**Before the Panel Convener appointed under the  
Fast-track Approvals Act 2024**

**In the matter of** Mt Welcome, Pukerua Bay

**Response to Panel Minute 18 (Planning)**

**7 September 2026**

**Figure 1: Western boundary active mode connection (red circle)**

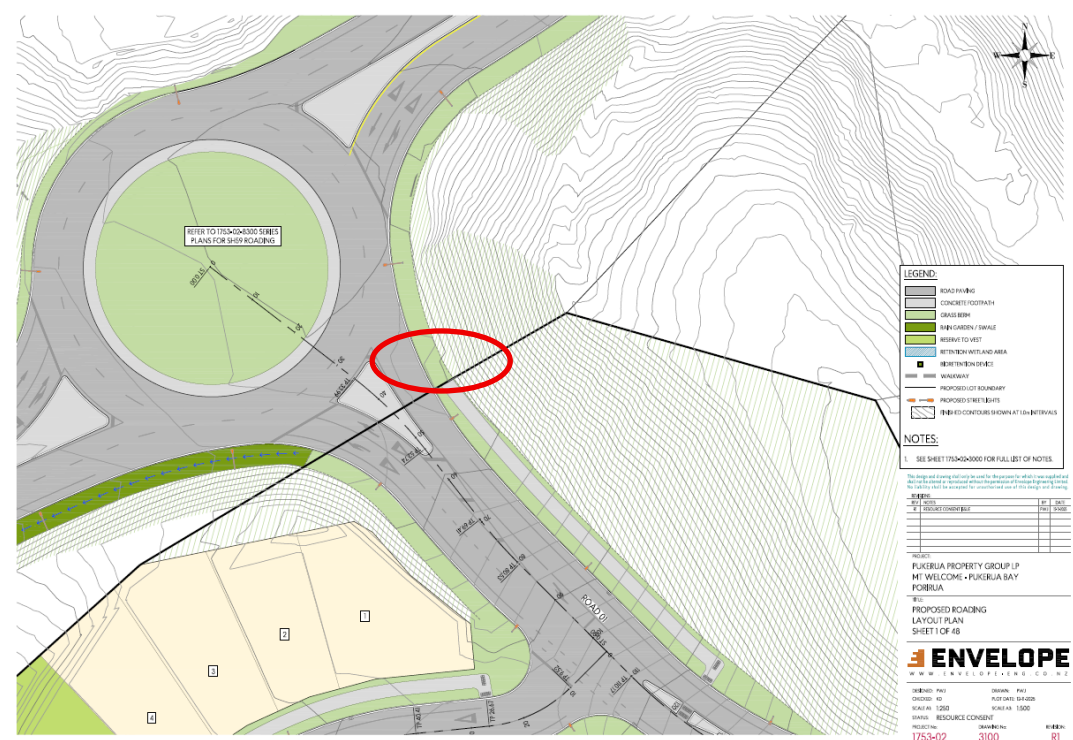
*[8] We confirm Commissioner McMahon's request of Mr Whittaker that he supply a graphic depiction of the proposed shared path option east of SH59 and within the road corridor by 5pm on 7 September. Related, and in the same time frame, we would appreciate an explanation from Mr McDonnell as to how the proposed link within the boundaries of the application site will be both enabled and required (e.g. by conditions etc) and some discussion about how its proposed extension over the Muri block is likely to be implemented through agreement/arrangement with the adjoining landholder and land developer.*

- 5 With regard to links at the boundary that provide for active mode connectivity to the east and north<sup>1</sup>, these are shown on the plans as per **Figures 1 and 2** below.

- 6 Proposed Condition 1 requires the development to proceed in general accordance with the information and plans submitted with the application. Because the active mode connections to the boundary are shown on those plans, Condition 1 provides certainty that those connections must be delivered to the boundary as part of the consented development. If they were not delivered, the development would not be in general accordance with the approved plans and would not give effect to the consent.
- 7 The Northern Growth Area Development Area provisions require the layout and design of the transport network to provide for boundary connections and active transport connectivity as follows<sup>2</sup>:

- 11 In summary, the proposed link within the application site will be enabled through the approved plans and required by Condition 1, which obliges the development to proceed in general accordance with those plans. The link to the northern boundary will therefore form part of the consented development. Its future extension across the Muri Block is expected to be implemented through the adjoining owner's subsequent development of that land, which is subject to the same District Plan framework requiring boundary connections and active transport connectivity.

**Figure 3: Structure Plan with site boundary shown approximately in yellow, and western transport and walkway connection circled in red**

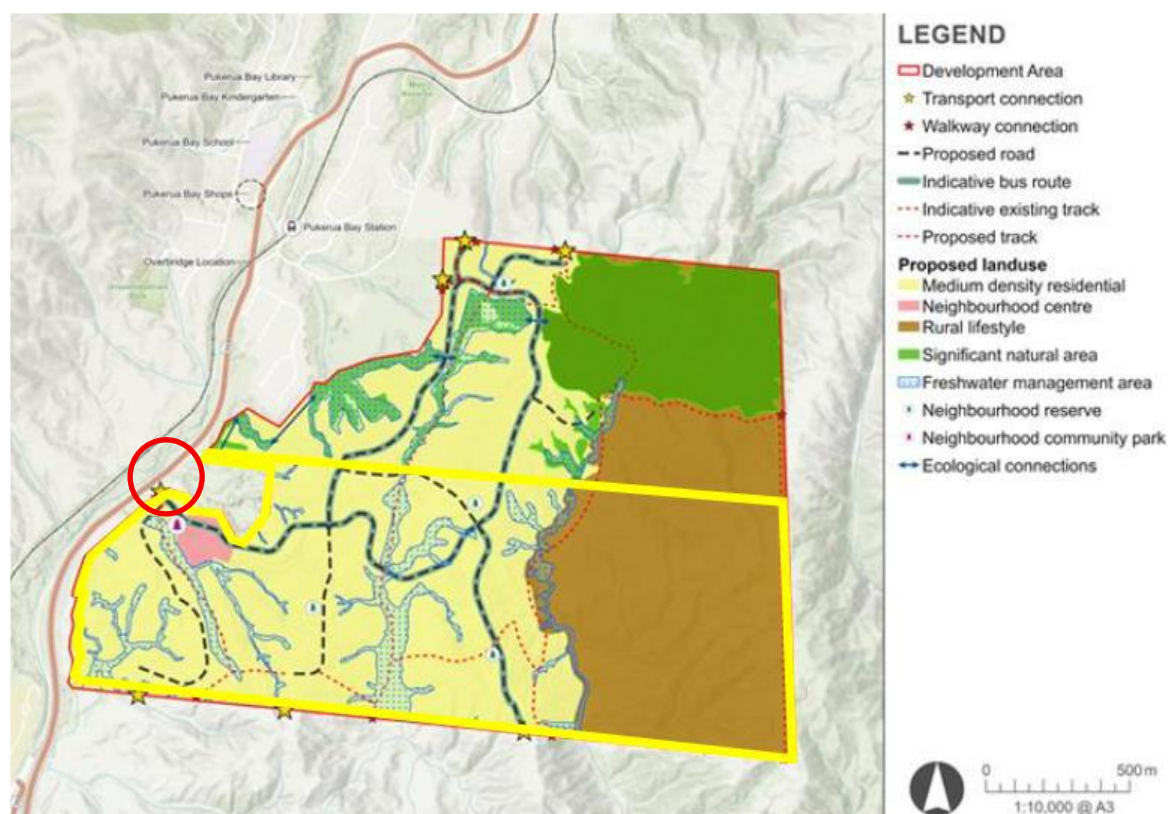
9 I note that the Applicant is not proposing an active mode connection across SH59 to the Ara Harakeke shared path on the western side of SH59. The Applicant is providing a connection consistent with the Structure Plan to the boundary of their site (red and yellow stars in **Figure 3** below). Neither the Northern Development Area Chapter not the Structure Plan requires delivery of the crossing.

- 10 The owners of the Muri Block will be subject to the same District Plan requirements when that land is developed. On that basis, the extension of the connection to the north is expected to occur through the future development of the Muri Block, including any agreement or arrangement required between the adjoining landholder and land developer. It is my understanding that the two developers are working together in partnership on shared infrastructure as the two sites are inherently linked in this regard.
